North East Link Eastern Freeway Upgrades - Burke Road to Tram Road - Urban Design and Landscape Plan

Submission from Boroondara City Council

Date: 27 November 2023

5.2 Musca Street Reserve

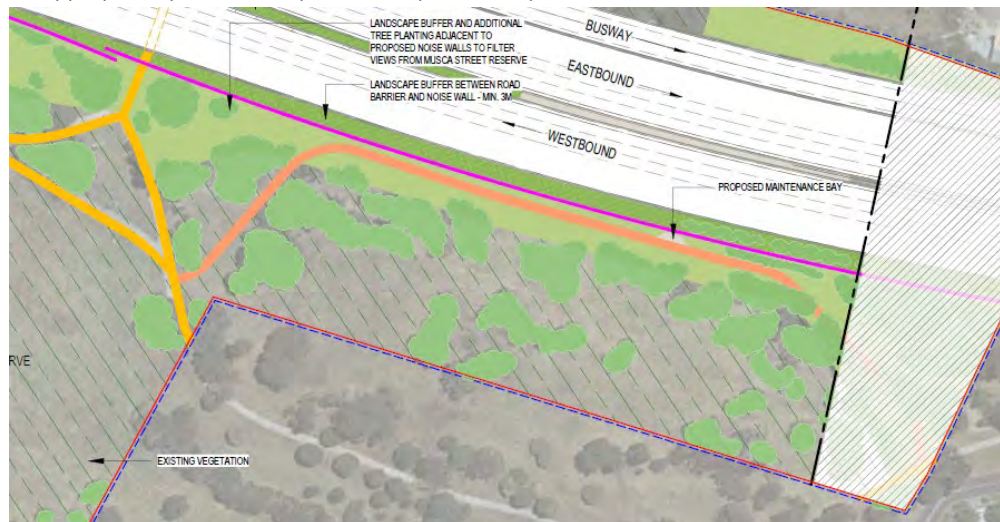
62. The encroachment of the freeway south into the open space illustrated on Landscape Drawing NO. 9536 is minimal and largely within the footprint of the existing freeway corridor. To the northwest portion of the open space, there appears to have been a gain of 2,752m² based on the difference between the existing fencing vs proposed noise wall alignment.

63. Despite this, considerable loss of vegetation is recorded along the northern edge of the reserve as per the Tree Removal & Reinstatement Plan snip below. It is understood that vegetation loss is linked to the construction of new noise walls. Given that the scale of Musca Street Reserve offers a generous buffer to residential land, it is recommended that the existing noise walls are retained if vegetation retention can be maximised.

5.4 Koonung Creek Reserve – East

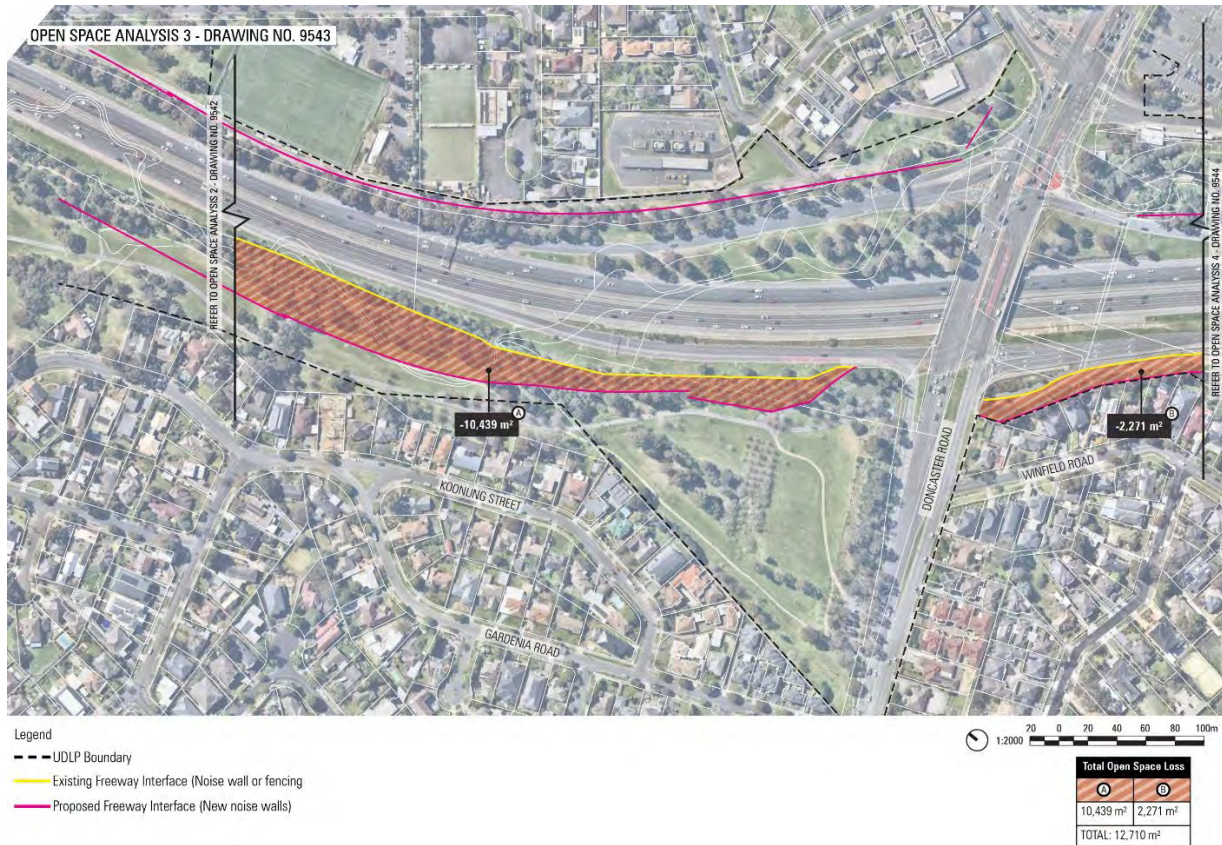
89. The encroachment of the freeway south into the open space illustrated on Landscape Drawing NO. 9536 is considerable, resulting in substantial loss of vegetation and informal open space with a strong riparian character. The southern encroachment recorded for this segment of Koonung Creek Reserve within the confines of Landscape Drawing 9543 is approximately 10,400m² of which is largely within the PPRZ.

90. To the eastern extent of Koonung Creek Reserve towards Doncaster Road sees considerable narrowing of the linear open space corridor and further loss of 'open' space to water storage infrastructure. While this eastern extent of the park is currently narrower relative to the broader open space to the west, it still caters to the trail and open areas for informal recreation activity. The southern encroachment of the freeway corridor sees a loss in these open areas, with the remaining cross section catering the trail, drainage swale and narrow segments of mixed grass, shrub planting and garden beds. The landscape plans illustrate generally little opportunity for tree plantings to screen proposed noise walls.

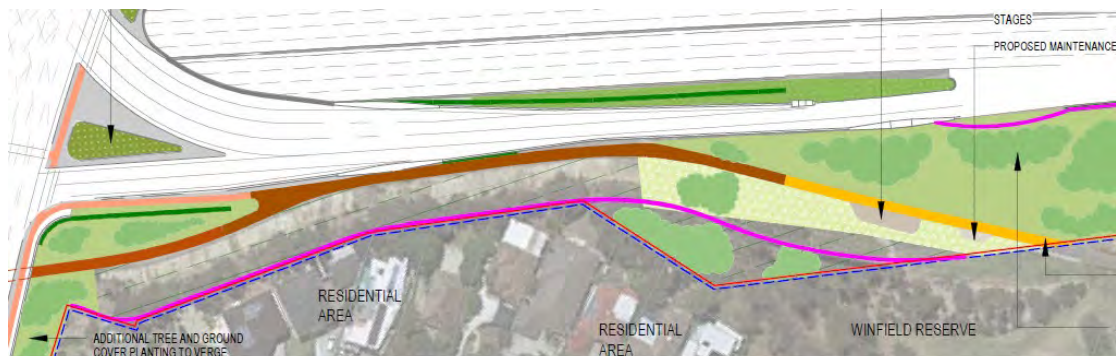
96. Elevations give an indication of the water management infrastructure levels. It is unclear how accessible they will be from the general public or whether fencing treatments are proposed or required. The character of these retention ponds are also unclear, as to whether they will have a wetland feel or a more structured, formal appearance.

97. Elevations provided generally lack detail regarding the look-and-feel of the service structure and fencing associated with the water pressure reducing station. Given its presentation to the open space, fencing and elevations should be responsive to its landscape character.
